## BUILDING CONSENT APPLICATION

BC 021305

**Building Consent**
**021305**
**Section 35, Building Act 1991**
**Application**

| Intended Use      | 4 Bedroom dwelling with study and garage and conservatory<br>340sqm. |

SUBJECT: Remedial work for support of brick veneer

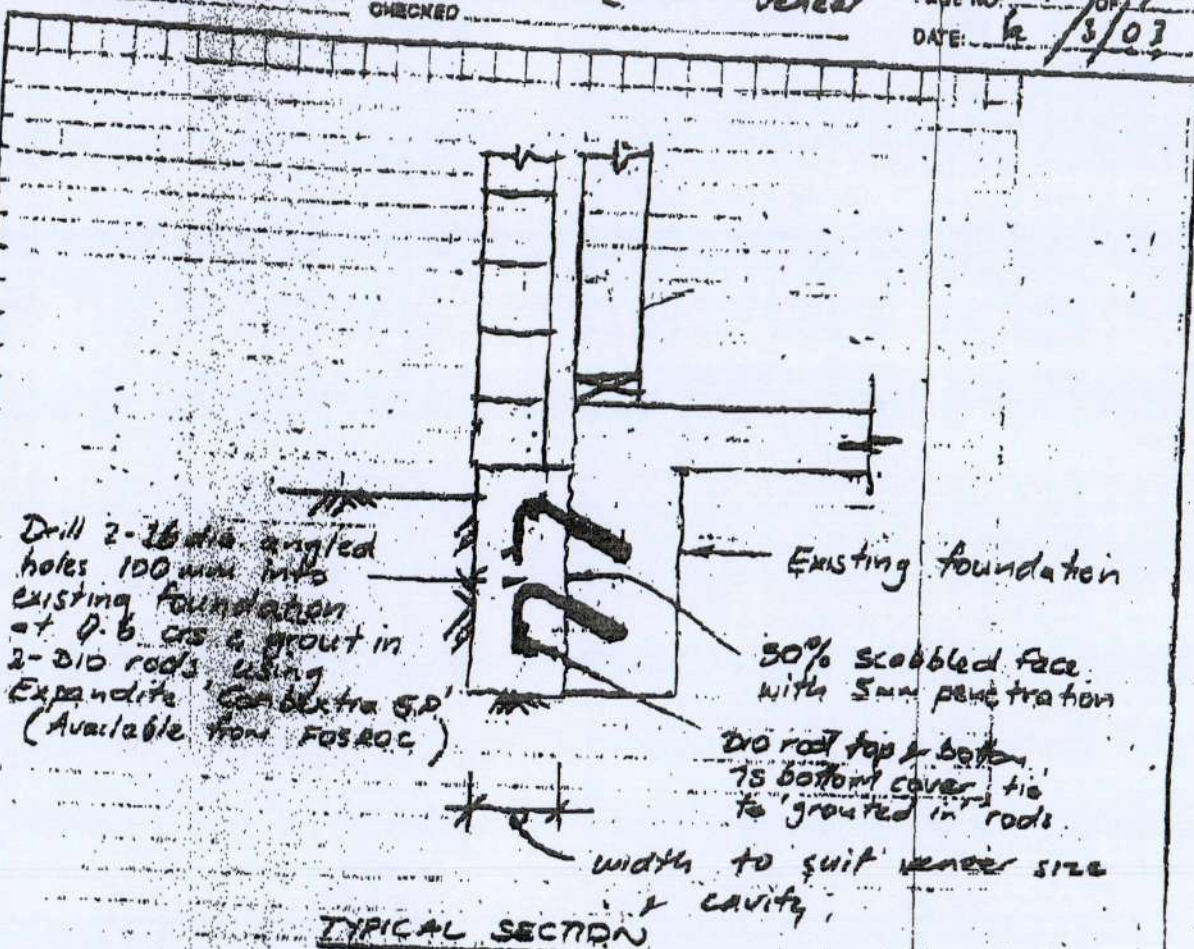
SPOKE TO MALCOLM DAVIS TO CLARIFY 'REMEDIAL' FOUNDATION WORK.

WINDOW AS PER ORIGINAL PLANS WAS TOO LARGE FOR 'NORMAL' GLASS. WINDOW WAS PUSHED OUT & MAIN PANE MADE 200 NARROWER, 2 SIDE (ANGLED) PANEES EACH MADE 100mm LONGER.

We have received a Producer Statement Construction Review from Eliot Sinclair for remedial work to the dwelling perimeter foundation, Council require a letter of explanation in regard to this Statement.

Please provide details of what work was involved, the extent of the remedial work and why this was necessary. I note that you have not provided us with any Design information for this work and your inspections sheets on our file do not make mention of any defective areas of work.

Project :- BC 021305. Reply to letter  
BR + J.L. Hayman 8/4/03Message :- I thought I sent through the  
Engineer's detail.There was no remedial as such  
had terminology by the Engineer.The footing needed to be extended  
as the Bay Window was too large  
The steel beams used would not  
support the size glass required.  
So they extended the two sides of  
the Bay so the front became  
smaller.As this type of construction is specific  
design I had the engineer design +  
approved its construction.

- 1) Excavate new foundation to at least the depth of the existing foundation.
- 2) After scabbling face of existing foundation wash down surface to remove loose debris etc.
- 3) Before grouting in anchor rods the fixing holes must be blown clean to remove loose debris etc.
- 4) Before concreting new foundation dampen down face of existing foundation to improve bonding surface.
- 5) Compact concrete with high frequency vibration.
- 6) Engineer to inspect foundation prior to pouring.

Resource Consent Required? NO

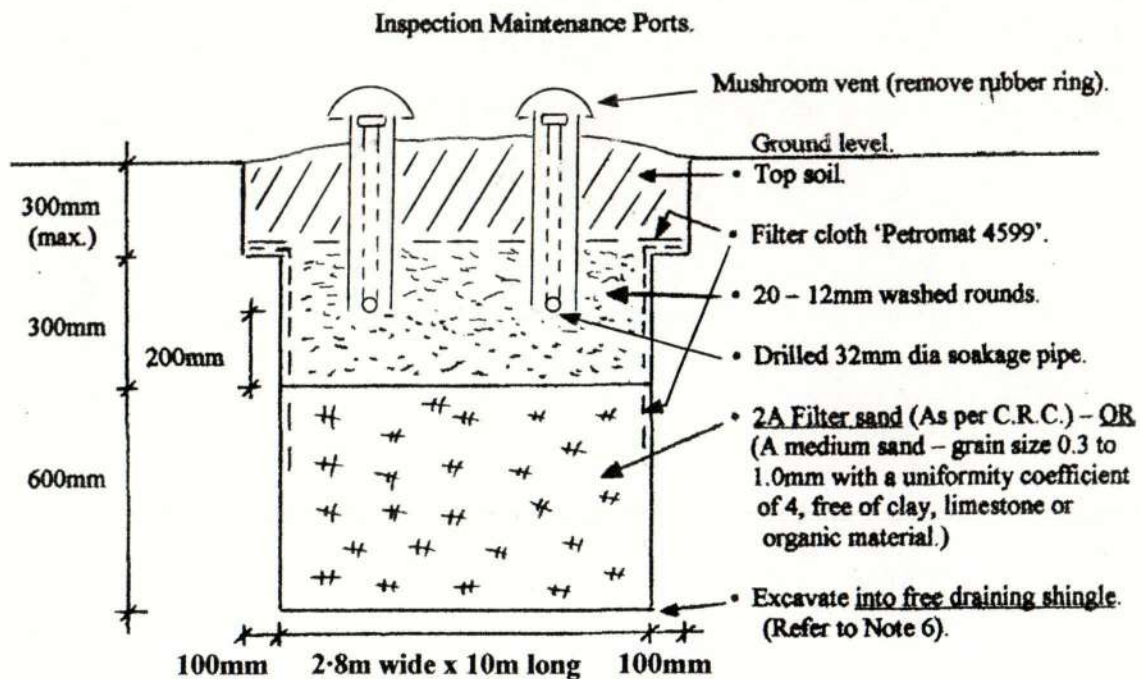
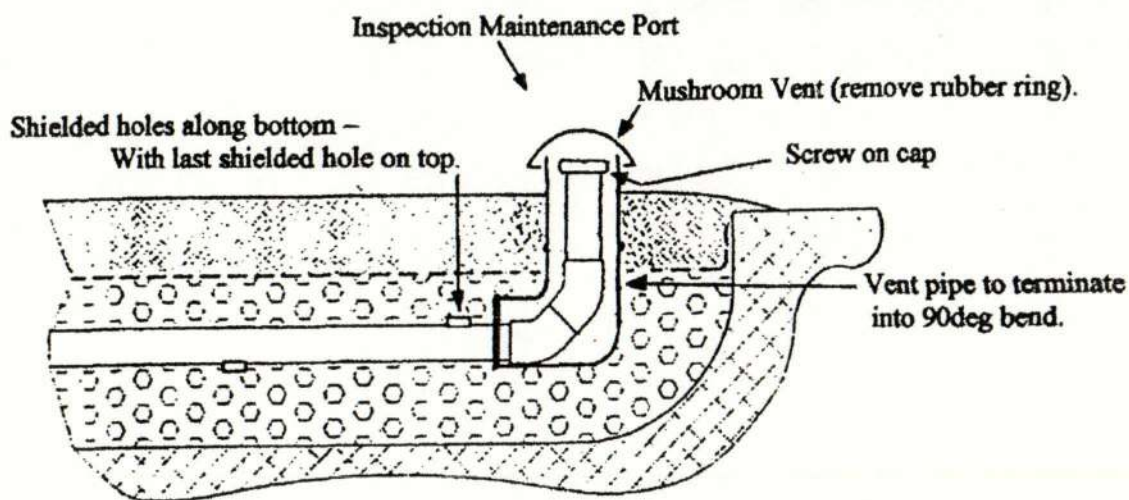
The amendment is in the layout of the disposal trench. The area of land available on site has meant that the disposal field needed amending, on Owner's request, as per site plans A & B dated 9<sup>th</sup> October 2002.

This will allow disposal field to comply with separation distances from planted trees on the property as required in Notes in Drawing No: B3364 and condition 5 of CRC consent.

- Disposal trench 2.8m wide x 10m long to comply with concept as per drawing No B3364
- Terminate ends of disposal pipe through a 90° bend and cap at ground level under mushroom.
- Disposal location as per Amended site plan A & B.

1. Minimum soakage trench area  $28\text{sq/m} = \text{Trench length} \times \text{width}$ . (Size given above is to fit into area owner wanted it placed and to be clear of planted trees to comply with CRC consent.)
2. Dimensions are minimum.
3. Material and pipe to be laid level.
4. Pump line to connect to centre of joining pipe between two soakage lines.
5. Slightly mound topsoil over trench when finished.
6. Trench excavated to depth as per plan. If while excavating trench good draining material changes, where trench needs to be deeper, fill the extra depth with free draining river run. Otherwise contact **D. C. & D. Ltd** for further instructions. (Test excavated depth with 10 litres of water to confirm good soakage).
